AGENDA
ZONING BOARD OF APPEALS
April 13, 2016
6:30 PM
CITY HALL, 101 GREEN STREET, GALENA, IL

RE: Cal. No. 16HCO-01, Applicant and Owner: Galena Prime Hotels, LLC (Betsy R. Achett), 11383 US Hwy 20 W, Galena, IL 61036. Location: Parcel: 13-001-079-00, Lot 2 of the Scholz Addition to the City of Galena, Section 11, Township 28 North, Range 1 West of the Fourth Principal Meridian, Galena, Jo Daviess County, Illinois. Common Address: 11383 US Hwy 20 W, Galena, IL 61036. Request for Non-administrative Highway 20 Development Permit to construct a 136-stall parking area to the Northeast of the hotel to facilitate on-site parking required for patrons at the event center.

RE: Cal. No. 16PD-01, Applicant: Adam Johnson, 211 Fourth Street, on behalf of Owner: Grace Episcopal Church, 107 S Prospect Street, Galena, IL 61036. Location: Parcel: 22-100-561-00, Lots 7, 9, 11 and South Half of Lot 5, Block 3 of the Original City of Galena, Jo Daviess County, Illinois. Common Address: 107 South Prospect Street, Galena, IL 61036. Request to rezone to Planned Unit Development for a site, with an underlying default district of Low Density Residential, to allow a building addition with associated site

PAVING, LANDSCAPING, LIGHTING PLAN

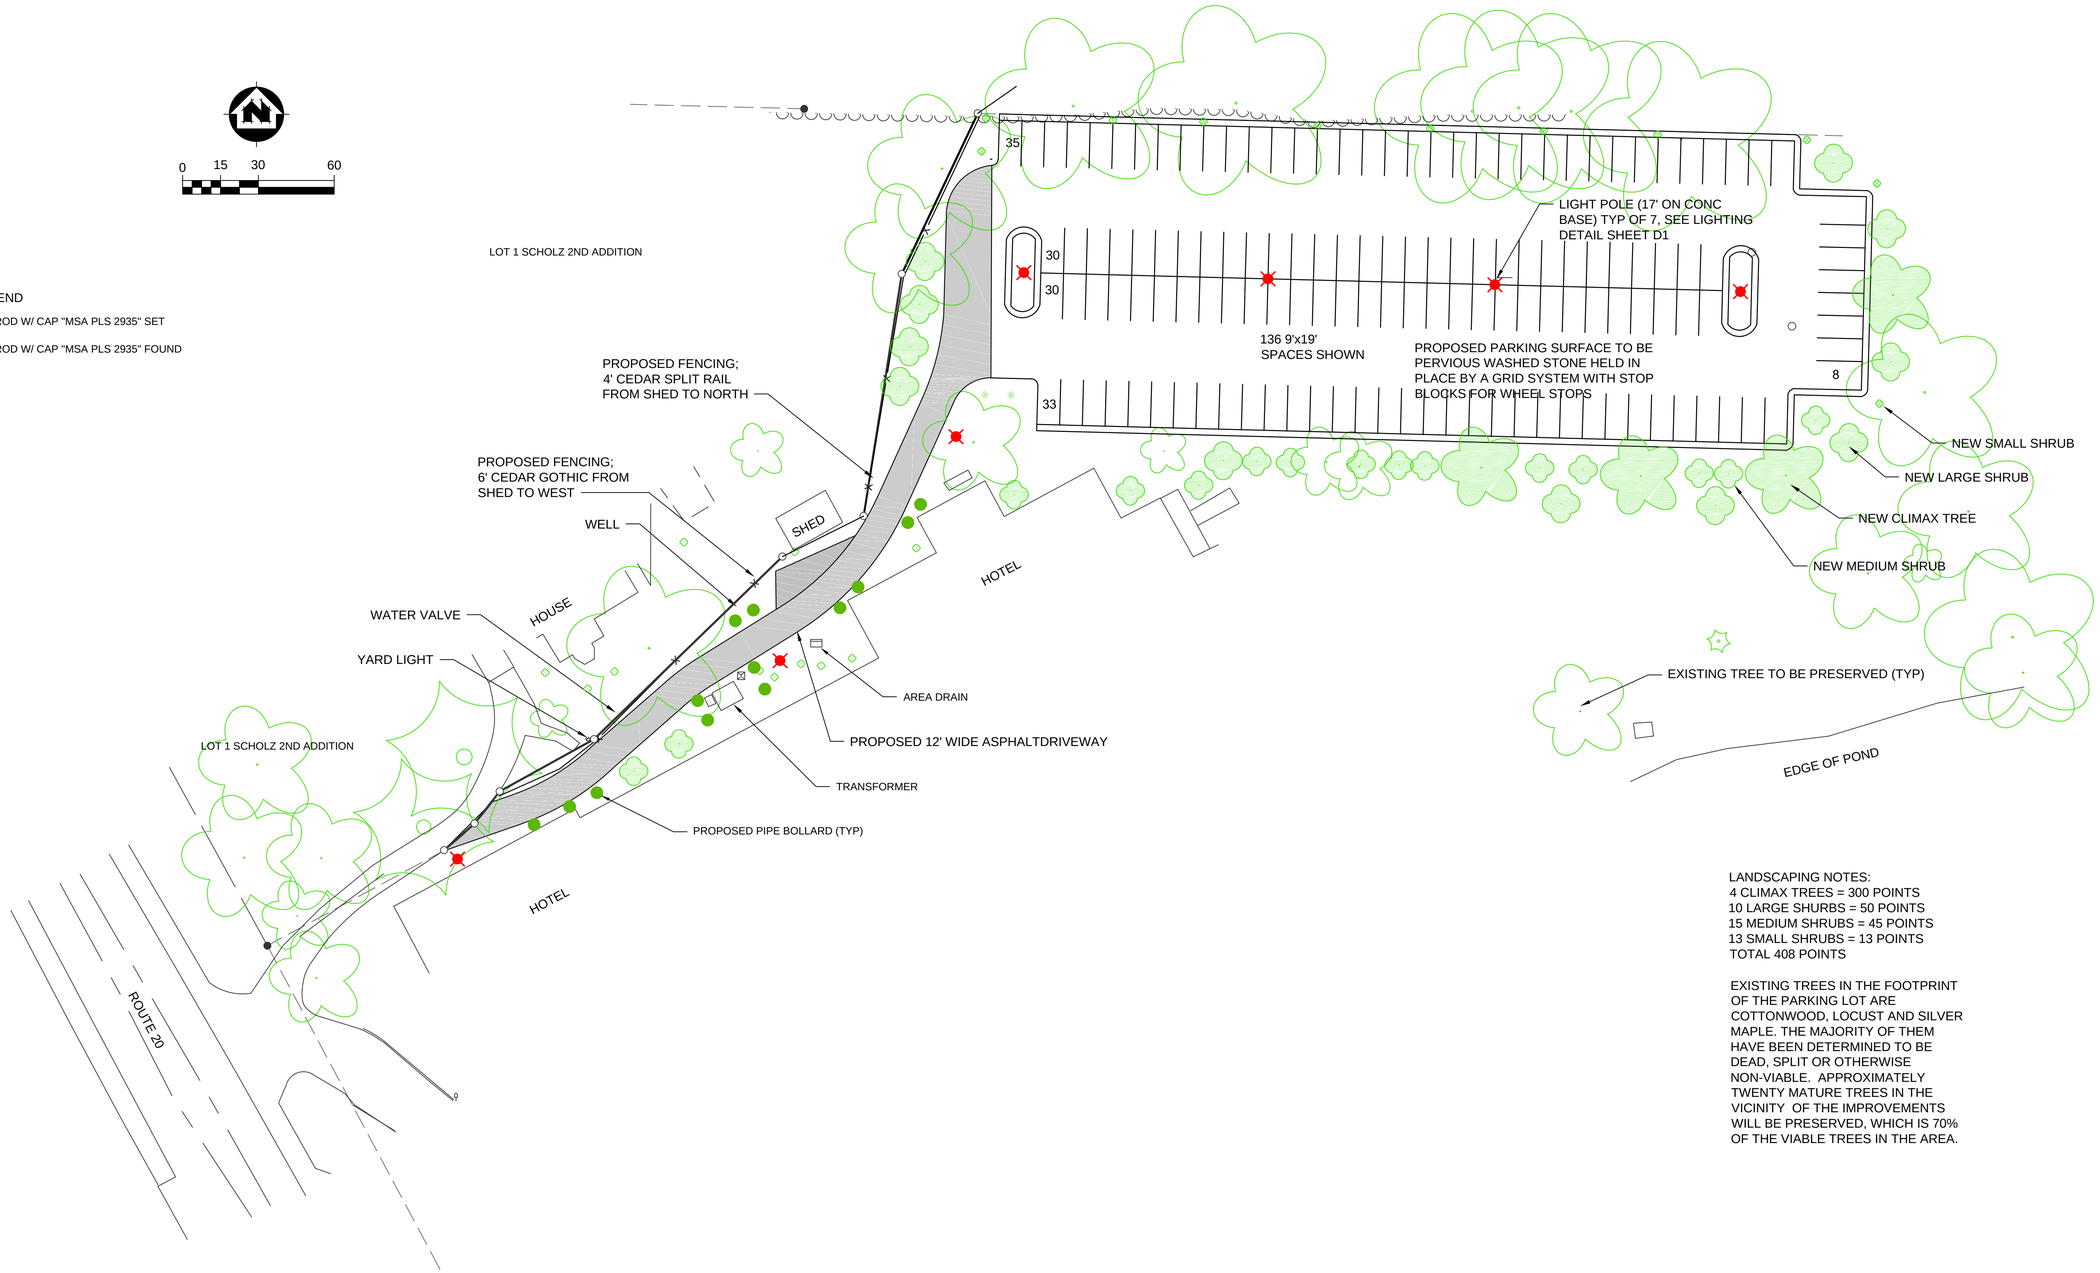
Staff has made multiple site visits and the following comments are included as part of the record to ensure compliance before a building permit is issued: ADA parking spaces required for this facility are 5 additional spaces. Phase one must have 3 accessible spaces and phase two must have an additional two spaces. Also, an accessible route must connect the parking area to the building. These requirements may be presented with the construction plans to the Building Department before a permit is issued. Proposed lighting and landscaping is adequate to provide safe travel by foot and safe circulation of vehicles. The landscaping improvements meets the requirements of the Code with plantings within 10 feet of the parking area to provide a visual

break and screens the parking area. The climax trees included will eventually regenerate the canopy and provide shading for the parking areas.

Proposed Site Plan
1" = 10'-0"

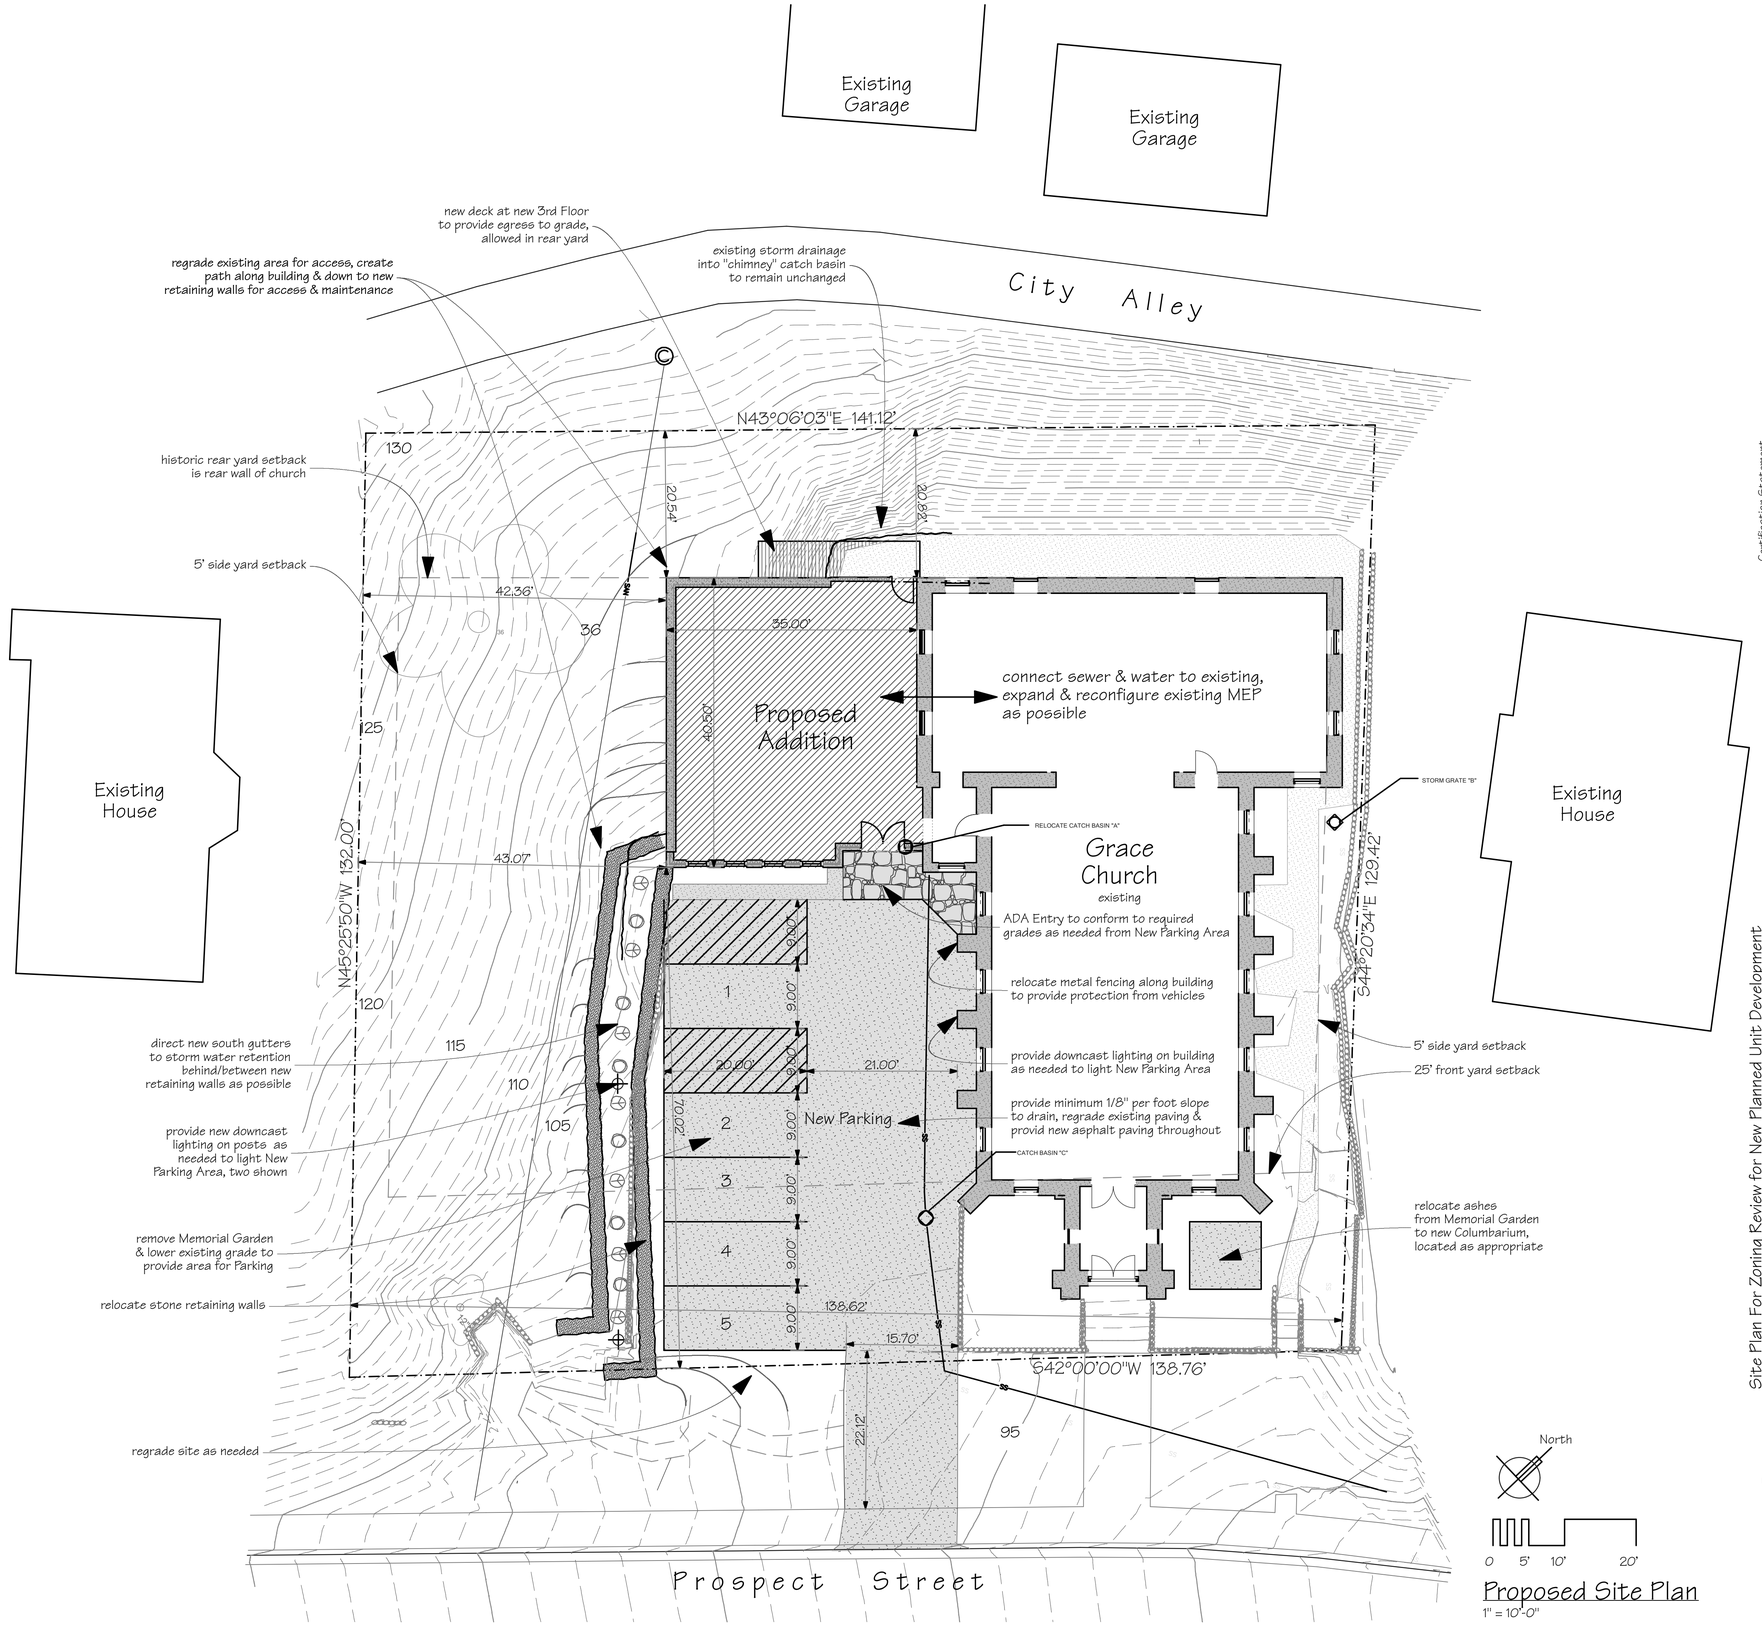
Meets lighting and landscaping standards provided in §154.603-605. Plan indicates placement of landscaping with exception of required screening on Prospect Street side of the parking area. Medium shrubbery will be required for this screening and is accepted by the owner. Parking standards identified in §154.601 will be discussed later in the review.

Proposed Third Floor Plan

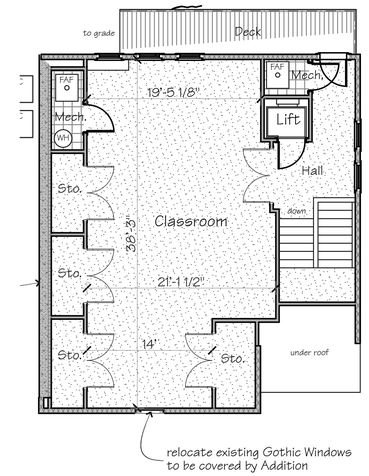
Building: Stamped, professional construction drawings must be submitted for final review with Staff before building permit is issued. ADA compliance is required. Egress walkway is called-out on drawing for the 3rd story fire escape; more detail is needed and can be submitted at time of construction document submittal.
